## WHITE HOUSE ACCESSIBILITY EVALUATION SUMMARY - June 2008

<p><b><u>Areas Evaluated:</u></b>  <b>Orientation/Signage</b>  <b>Exhibit 1 - First Families</b>  <b>Exhibit 2 - Symbol and Image</b>  <b>Exhibit 3 - White House Architecture</b>  <b>Exhibit 4 - White House Interiors</b>  <b>Exhibit 5 - Working White House</b>  <b>Exhibit 6 - Ceremonies and Celebrities</b></p>
<p><b>Overall Exhibit Facility</b></p>	
<p><b>1.</b> Does access to the exhibit meet the HFC and ABAAS guidelines for circulation space throughout the exhibit area? (36"-wide clear width for passageways, requirements for turning spaces, etc. p. 24- p.26)</p>	<p>The exhibits meet the minimum wheelchair access standards, but there are pinch points in areas between the building columns and where the exhibits jut outward which are awkward for visitors in wheelchairs. There are some other places that are awkward to navigate, between the freestanding vertical exhibit units and the exhibits along the wall. An example of one of the pinch points behind a column is shown in Photo No. 1. The clearance here is 41 inches.</p>

Photo 6

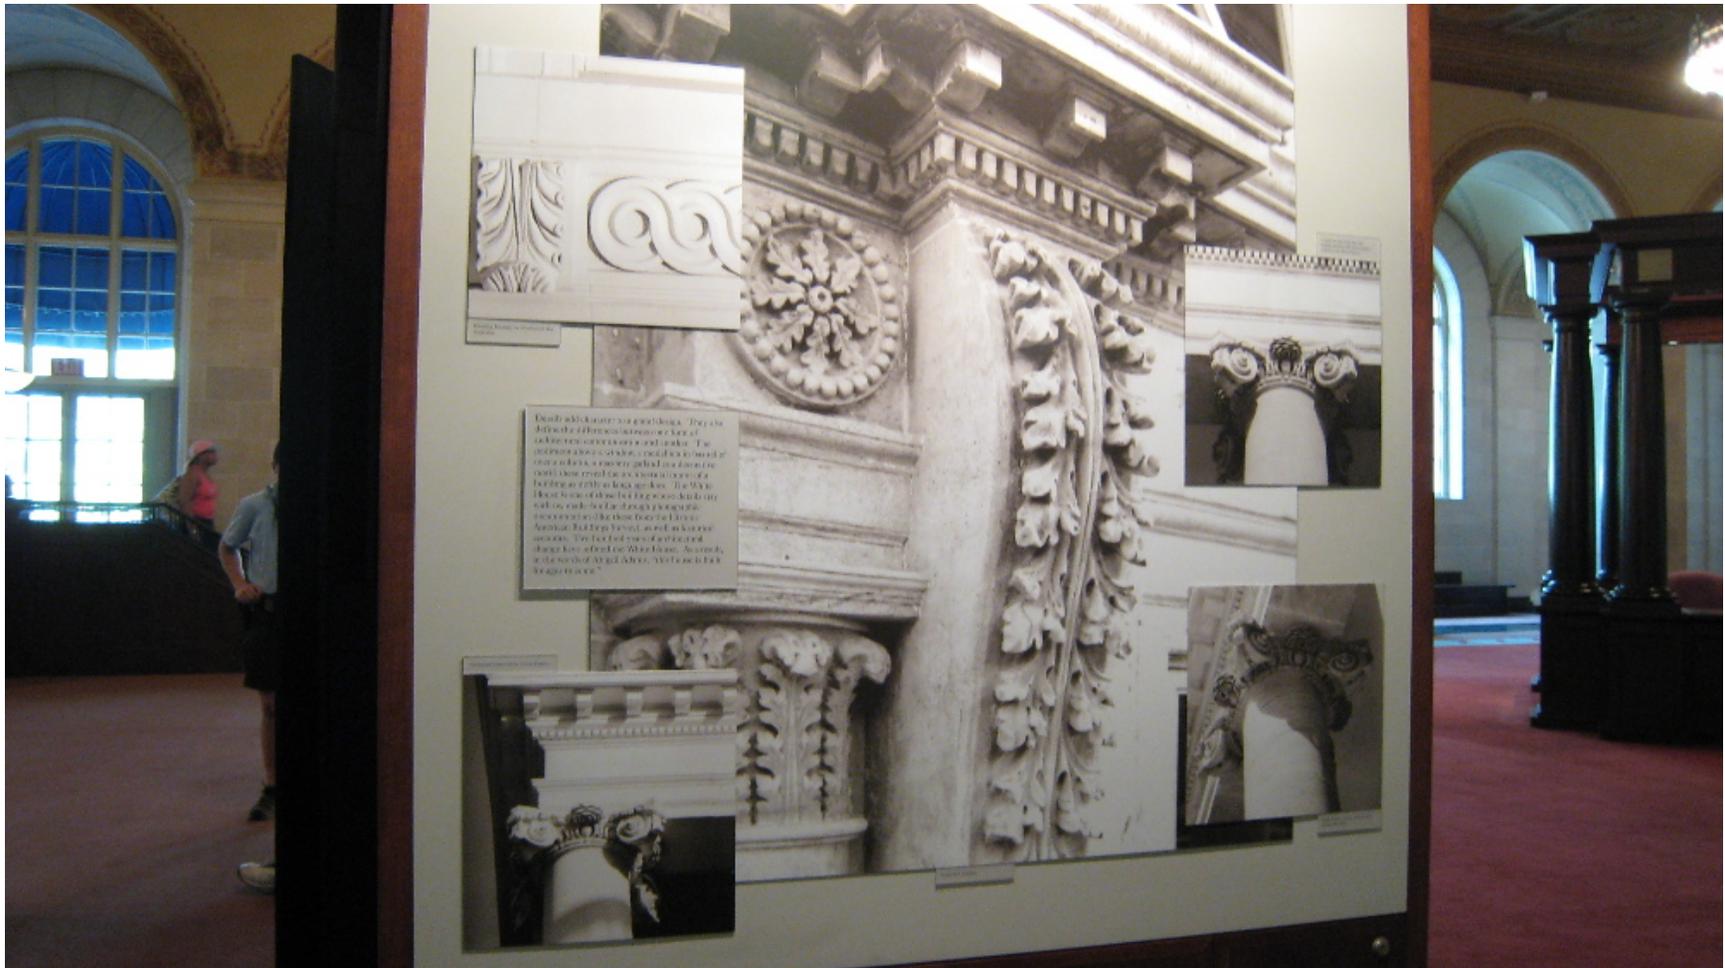
These are 2D images, but 3D casts of the same thing would make the exhibits much more accessible and interesting.
